Our reference: P-603321-COL3
Contact: Sandra Fagan
Telephone: (02) 4732 7992

Council Response to EIS Report - SSD-60513208 – Stage 4 – Warehouse 8 – Aspect Industrial Estate at 804–882 Mamre Road, Kemps Creek, NSW, 2178.

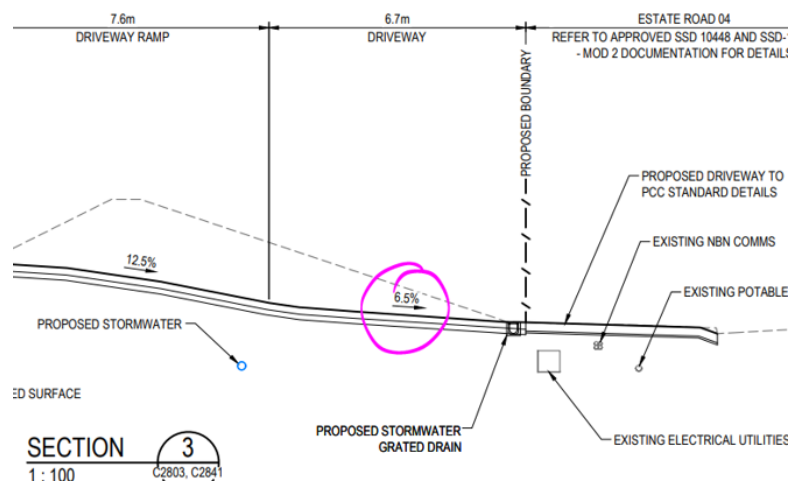
- i. the vehicular access must be located a minimum of 6m from the tangent point (TP) of the curve return and must be reflected on the detailed plan.
- ii. the accesses must provide sufficient clearance from any infrastructure such as kerb/pram ramp, stormwater side entry pit, and any street trees. All infrastructure must be shown on the plans with their separation from the proposed accesses/laybacks.
- iii. at least the first 6m of access driveway into the car park must have no more than a 1 in 20 (5%) grade in accordance with AS 2890.1. Although the relocated access will service user class 4, the Dwg. No 2810- Section 3 by AT&L indicates higher than 5% grade for the first 6m of the access driveway (as shown on the snippet below) which should be amended to comply with AS 2890.1.

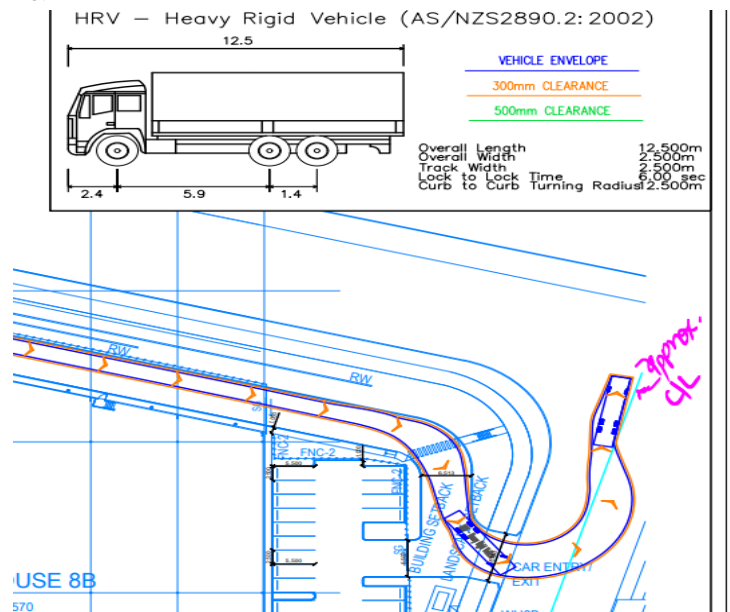
- iv. accesses must achieve sufficient sight distances in accordance with the relevant Australian Standards AS 2890 and must be shown on the plans.
- b. The swept paths for various types of vehicles using heavy vehicle accesses for tenancy 8A, 8B, and the proposed relocated vehicular access for consolidated carpark are included in the transport statement by Ason Group. Based on these swept paths, the following comments are provided for consideration:

- i. the swept paths indicate that the new heavy vehicle access for tenancy 8B is only suitable for up to 20m articulated vehicles (AVs).
- ii. the swept paths indicate heavy rigid vehicles (HRVs) encroach the centreline of Road 4 while exiting Lot 8 using the relocated access from the carpark. This is not acceptable. Subject to satisfactory swept path diagrams, this vehicular access may only be suitable for B85, B99 and SRVs.

- c. Based on the above points (i and ii), it is not clear how the accesses will be managed and regulated to ensure entry/exit (use) by vehicles no bigger than those mentioned above.
